CITY OF ALBUQUERQUE

**Re: Bralco Metals, 6718 Jefferson NE,
Permanent Certificate of Occupancy - Approved
Engineer's Stamp dated: 04-27-11 (E-17/D072)
Certification dated: 06-14-11**

Re: Bralco Metals
Drainage and Grading Plan
Engineer's Stamp dated 4-15-11 (E17/D072)

Re: Bralco Metals
Drainage and Grading Plan
Engineer's Stamp dated 6-14-11 (E17/D072)

Previously
approved

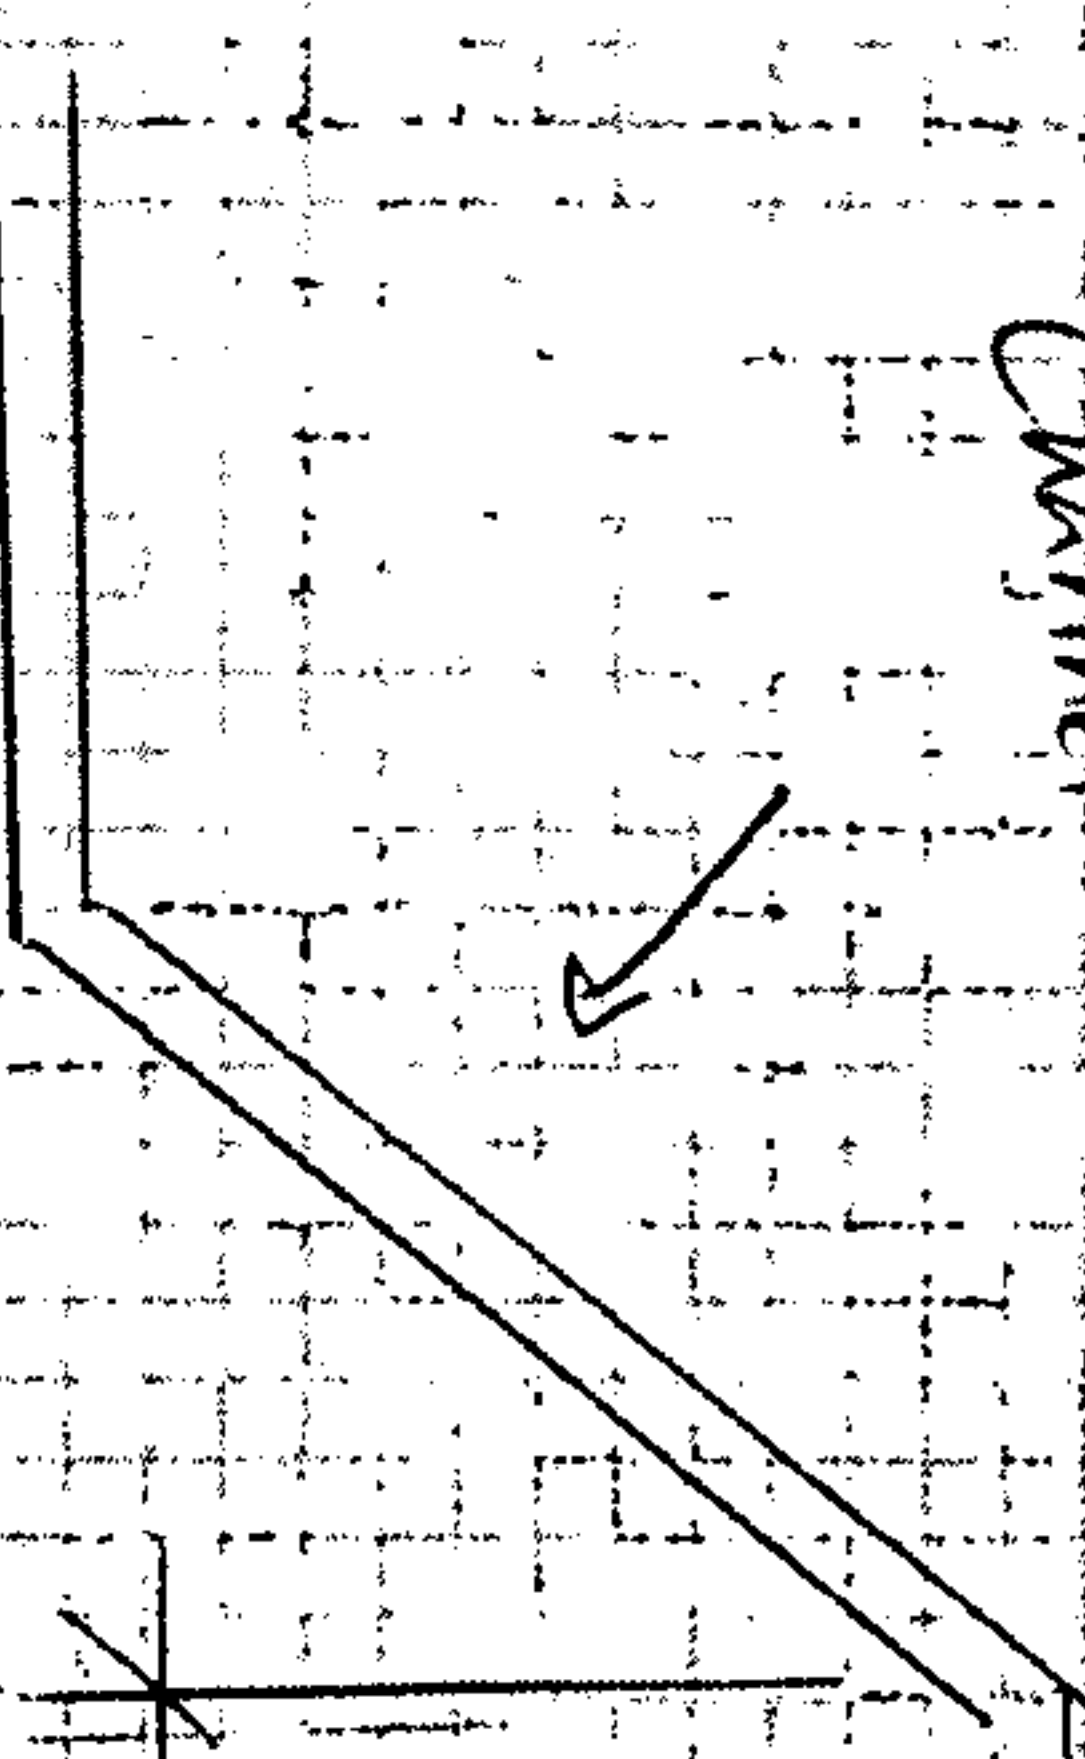
As discussed today I've done a hand drawing of the small change in the Bralco Metals shotcrete turndown, and I've talked to Curtis, and he's given his okay with the design. The approved turndown has a 12"

depth right next to the steep slope, and it is almost impossible to dig the 12" down without sloughing off the top of the slope. I recommend a 6" deep thickened edge instead with a 3" flat top. The 6" depth will have 3" buried and 3" exposed. Please see the attached drawing for details.

{ Steep slope makes it difficult to
dig 12" of Trench so close to the edge }

new proposed
the trench edge

Proc@eed

As we talked over the phone a few minutes ago, you need to have 10 feet for the maintenance road, so it is not feasible to add a 12" shotcrete top, since it will limit the 10' to less. Right now we have 10' and a little more at certain parts. You have agreed to go with the 6" deep and 3" top section for the shotcrete as I proposed. I appreciate the quick response.

I would rather that you mirror the other side. (ie. have flat area on top of the maintenance road - - maybe 1' or so) I assume that the owner knows he is responsible for this.....

Drawing for Brake Metals

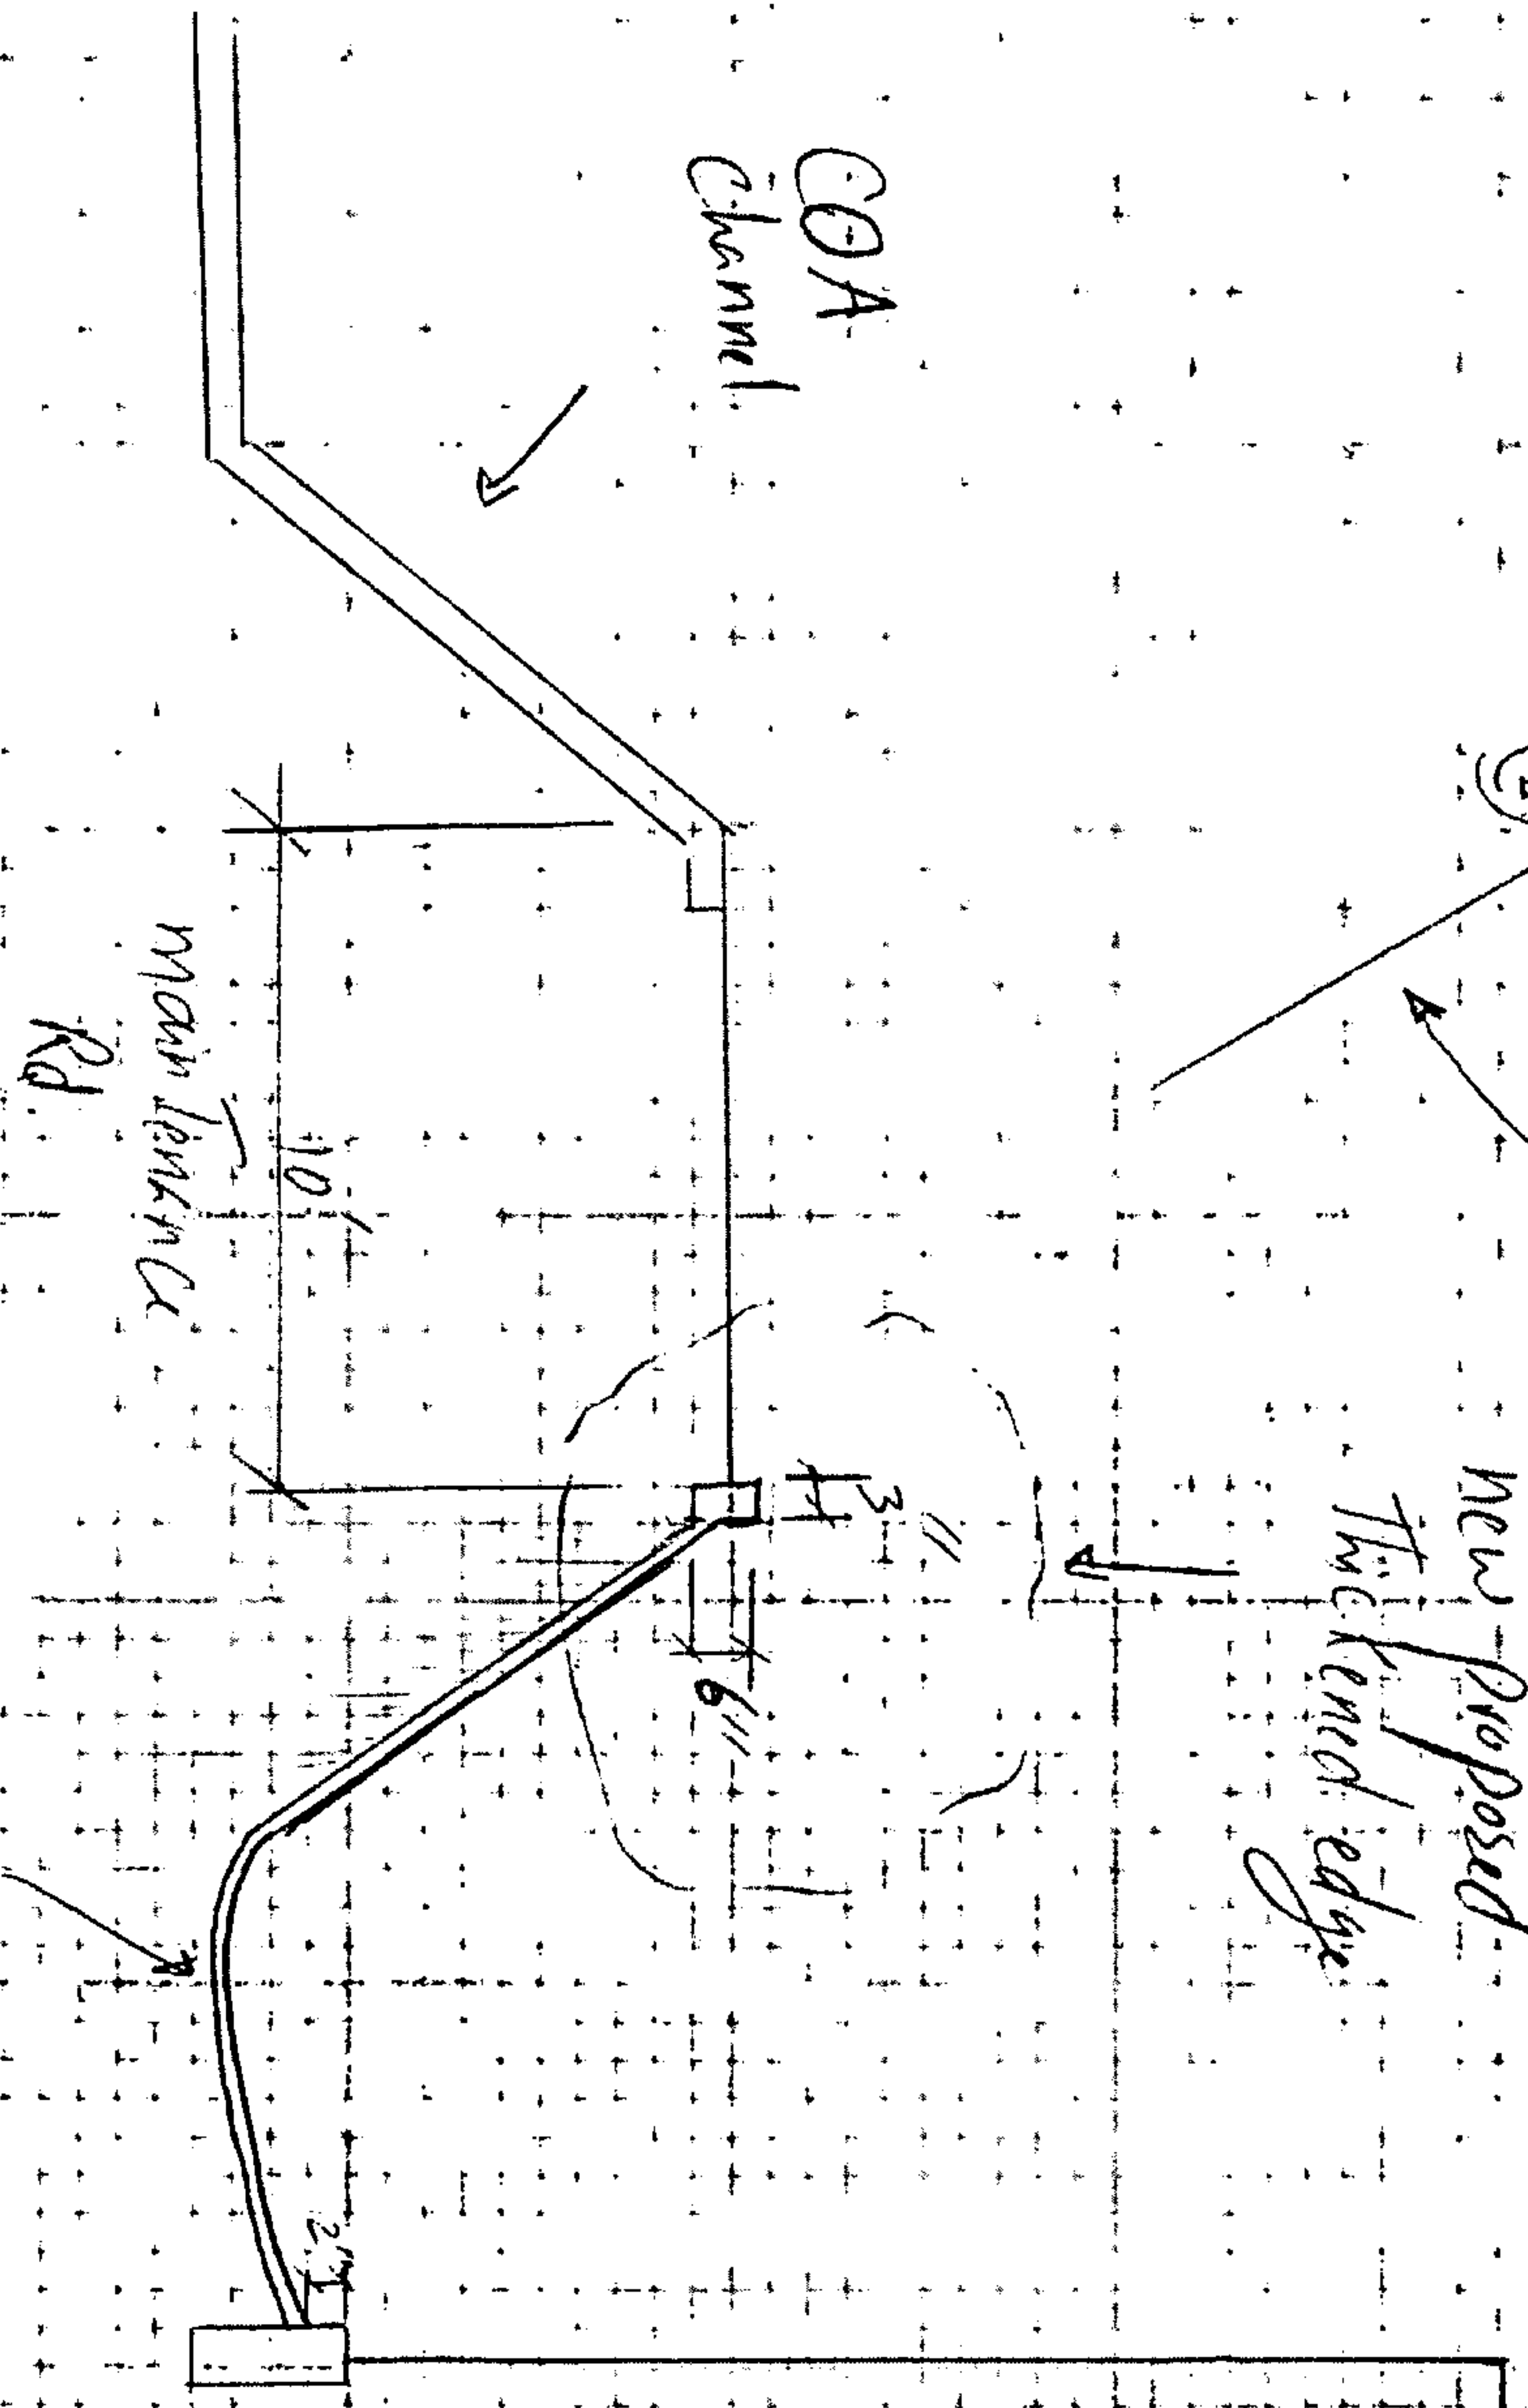
{ Steep slope makes it difficult to dig 12" of Trench so close to the edge }

new proposed thickened edge

(DESCRIBE ANY EXCEPTIONS AND/OR QUALIFICATIONS HERE IN A SEPARATE
PARAGRAPH) The 12"x1" block at top of shotcrete was changed to 6"x3" block as
approved by Mr. Wilfred Gallegos (see attached correspondence)
